DESCRIPTION OF PROPOSED CHANGES NPF-10-8 AND NPF-15-8  
AND SAFETY ANALYSIS

This is a request to revise Technical Specification 3/4.6.3 - "Containment Isolation Valves."

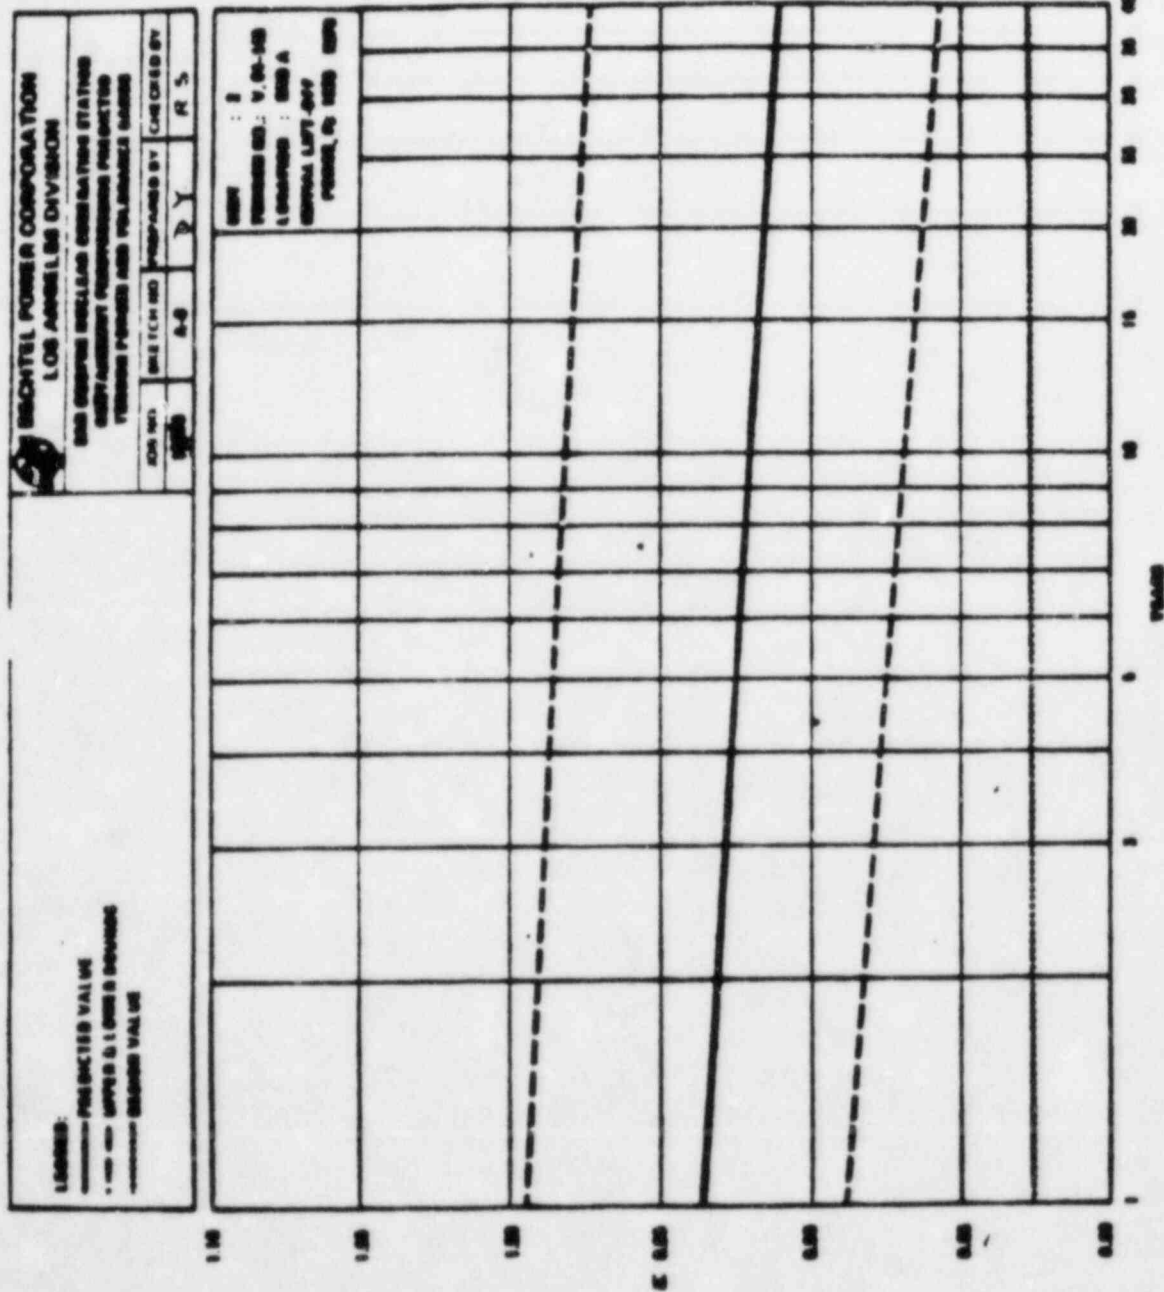
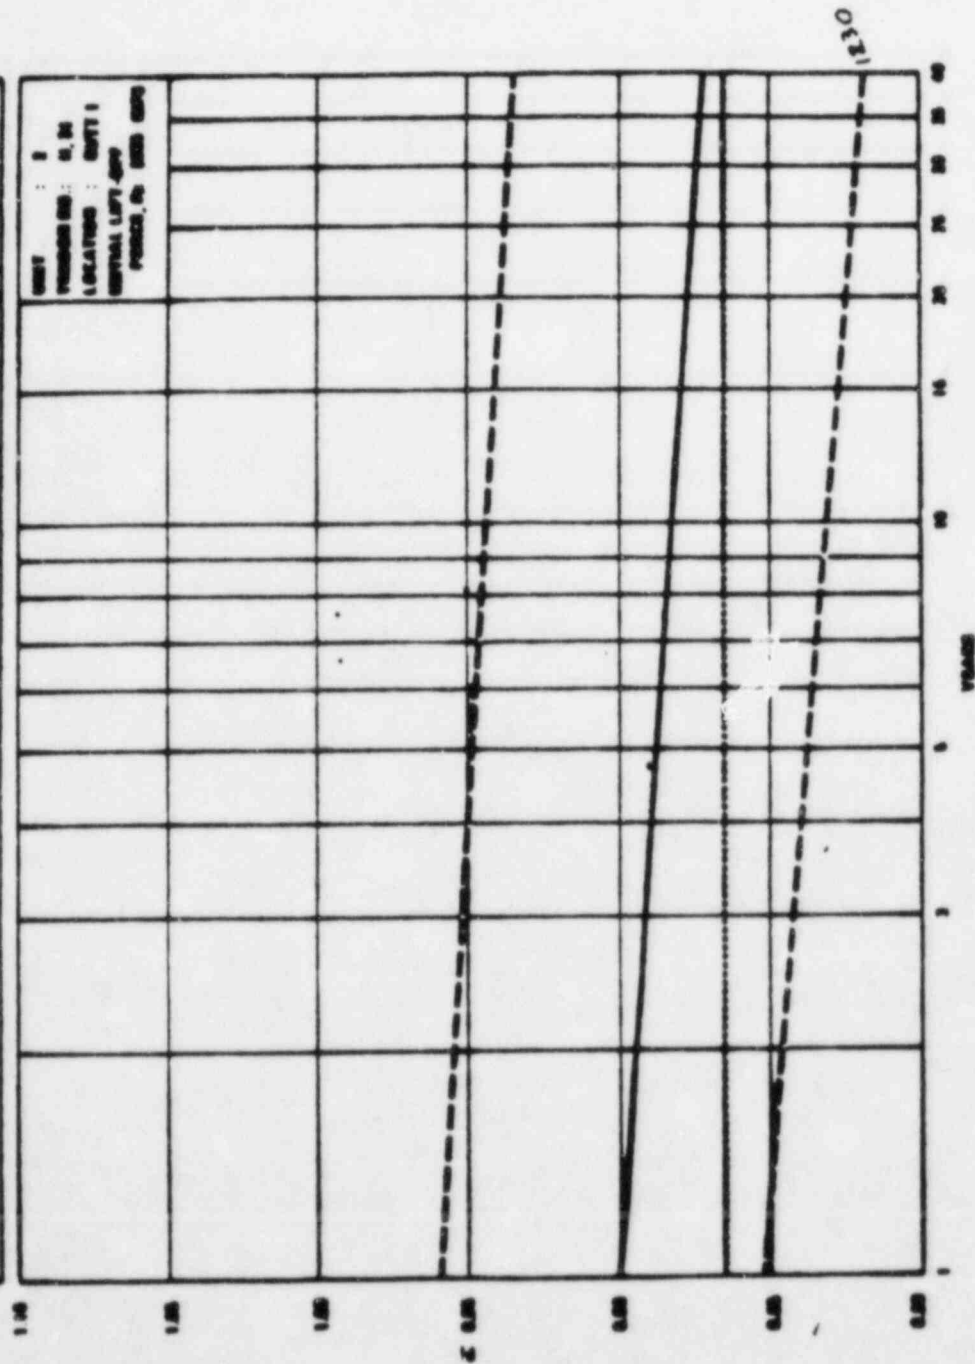
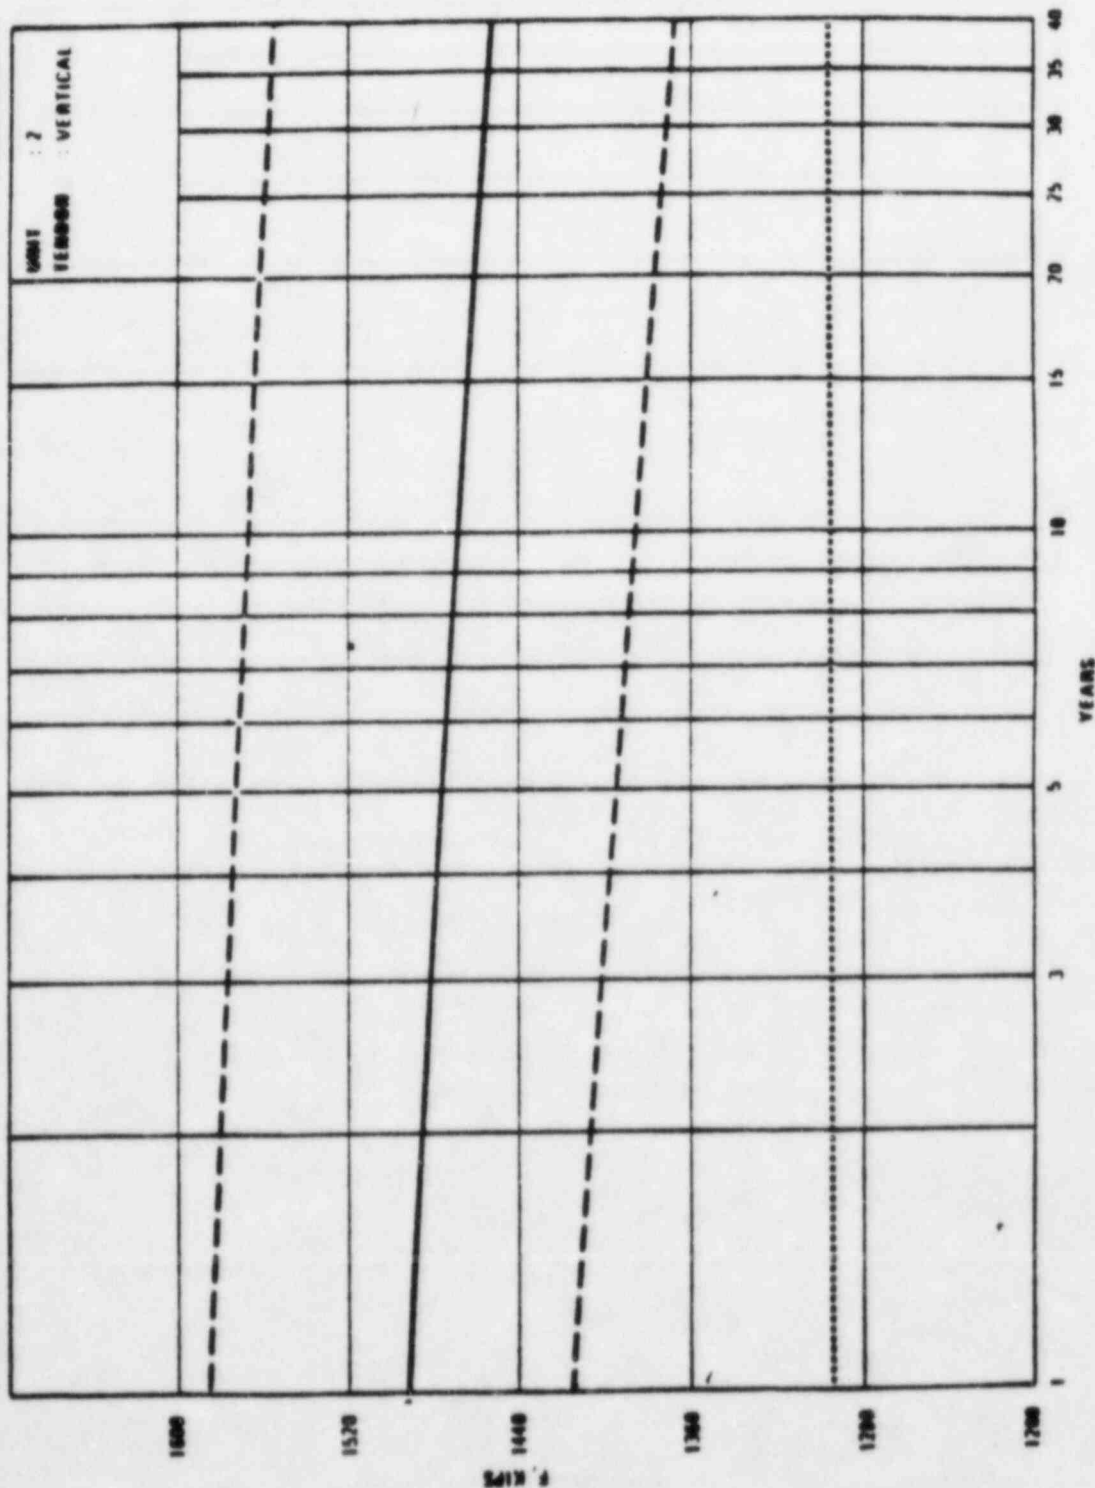
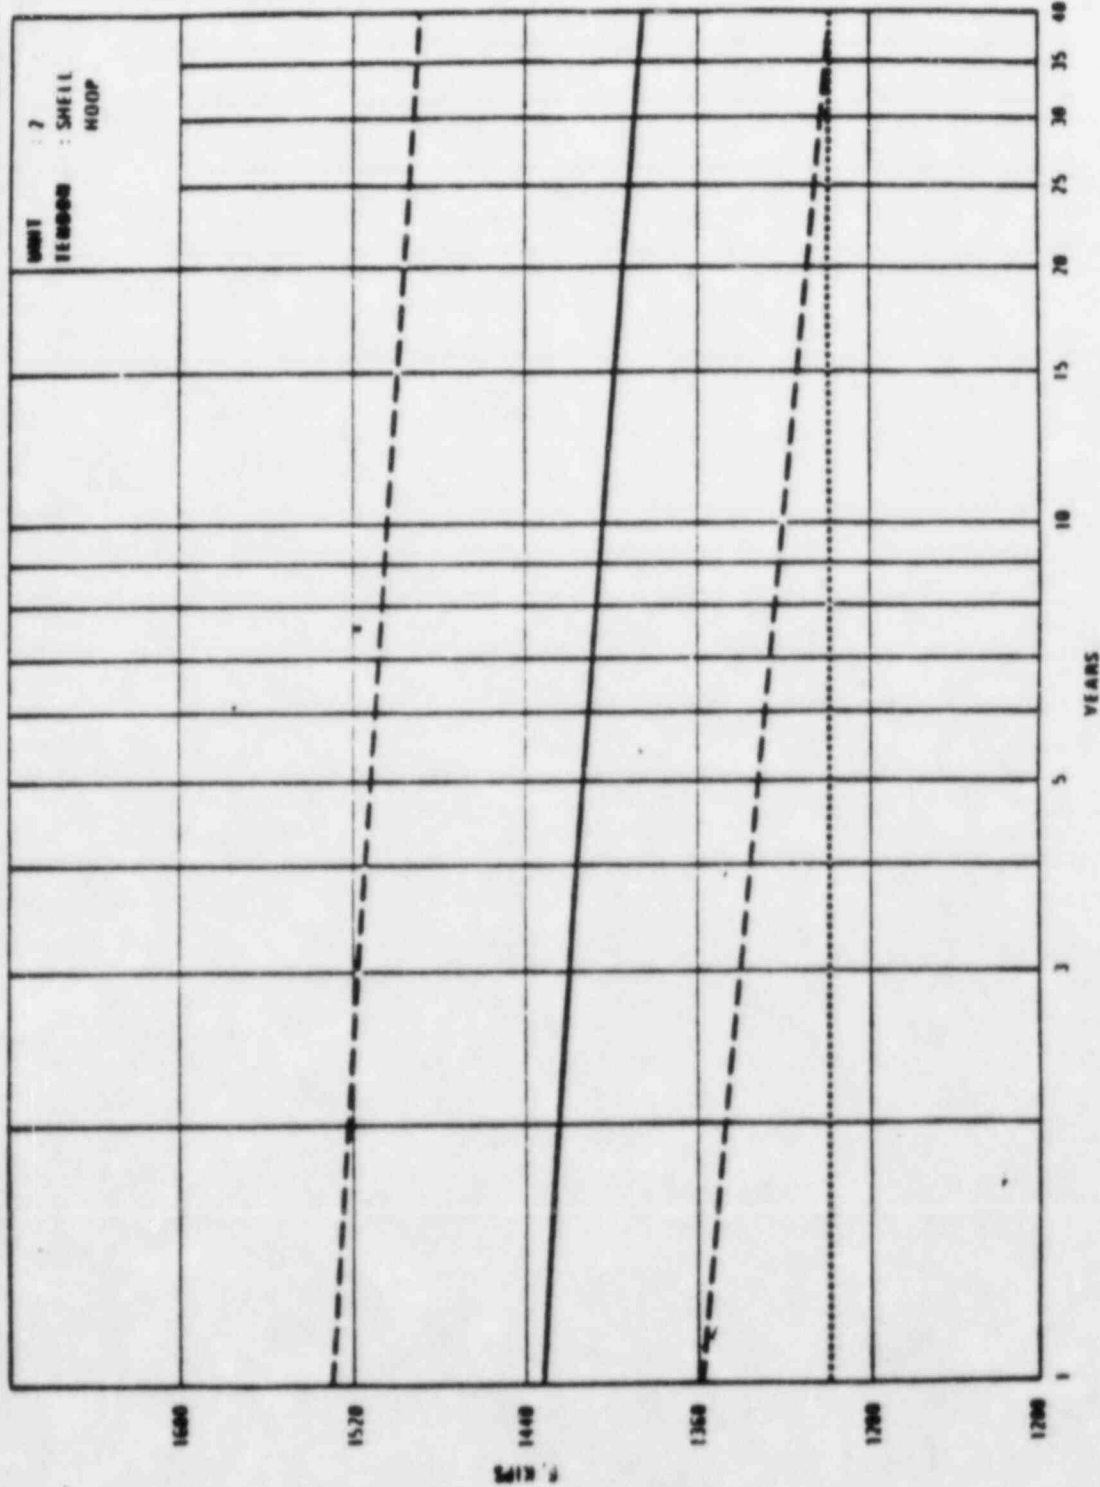
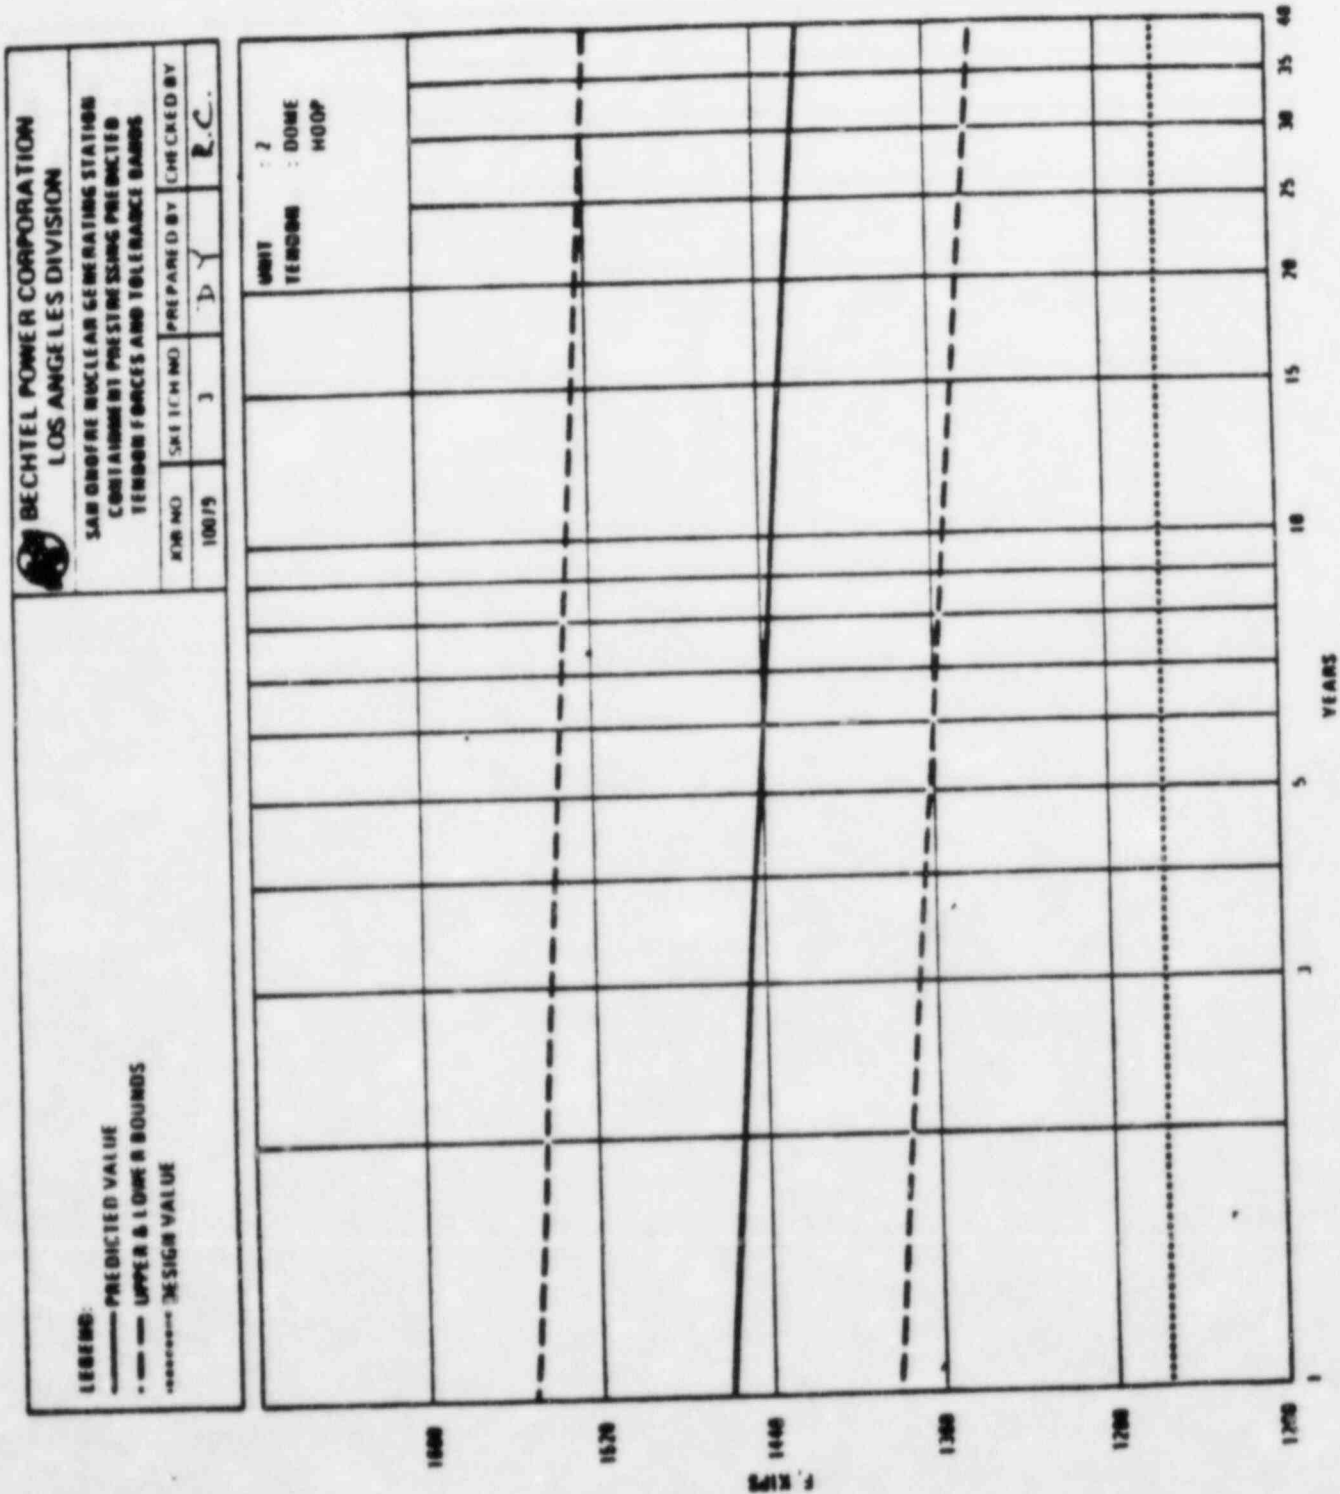
3. The remainder of the changes to Paragraph 4.6.1.6a provide clarification that the tolerance band values, particularly the upper one, are not to be treated as minimum and maximum limits but, rather, as surveillance guidelines. Specific actions associated with these guidelines are given at the end of the paragraph.

This has been done for each surveillance tendon with the predicted tendon force and upper and lower bounds plotted on semi-log paper. Two of these curves are attached to this report as figures 1 and 2. It is noted that these figures also indicate the design prestress level as determined from the VSL calculations taking into account the added tendons.

FIGURE 3.1 - 1A

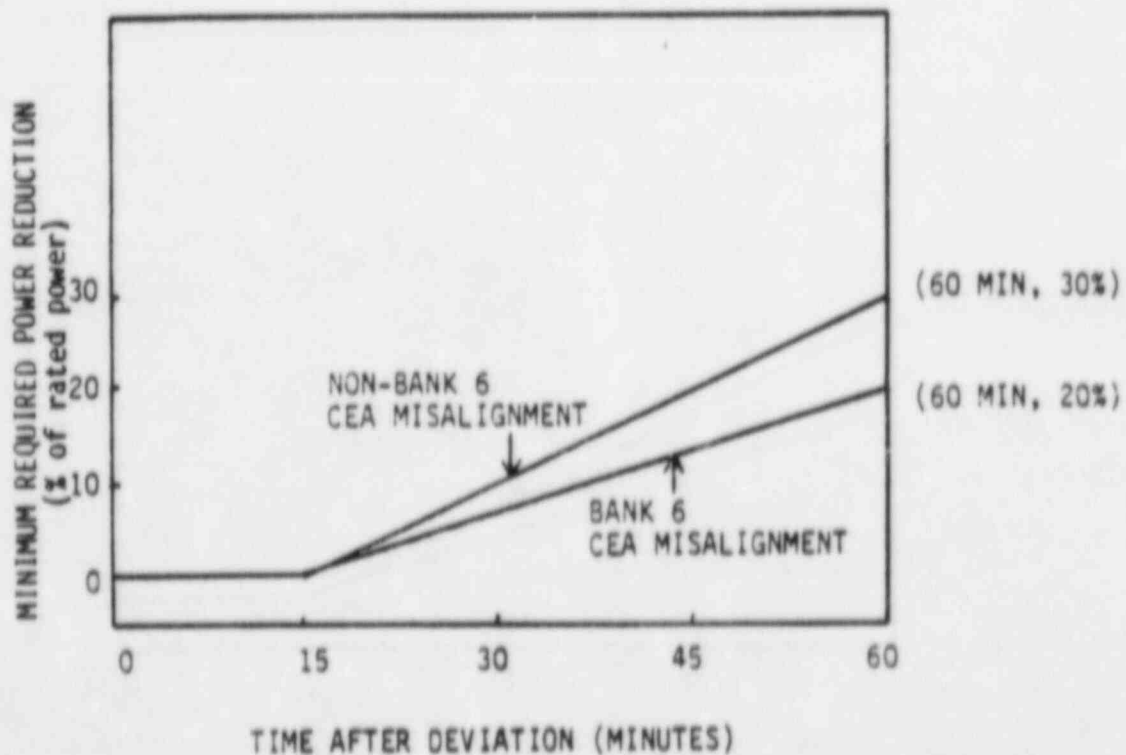
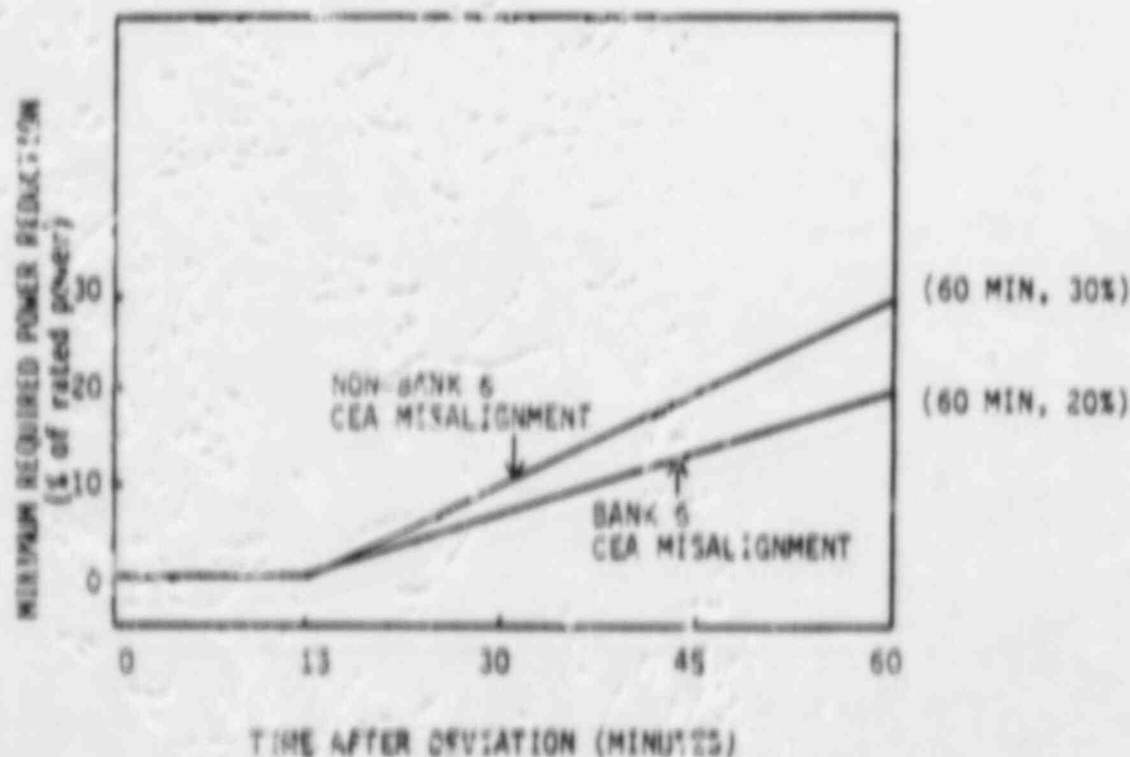
- c. With one full length or part length CEA misaligned from any other CEA in its group by more than 19 inches, operation in MODES 1 and 2 may continue, provided that core power is reduced in accordance with Figure 3.1-1A and that within one hour the misaligned CEA is either:

- d. With one or more full length or part length CEAs misaligned from any other CEAs in its group by more than 7 inches but less than or equal to 19 inches, operation in MODES 1 and 2 may continue, provided that core power is reduced in accordance with Figure 3.1-1A and that within one hour the misaligned CEA(s) is either:
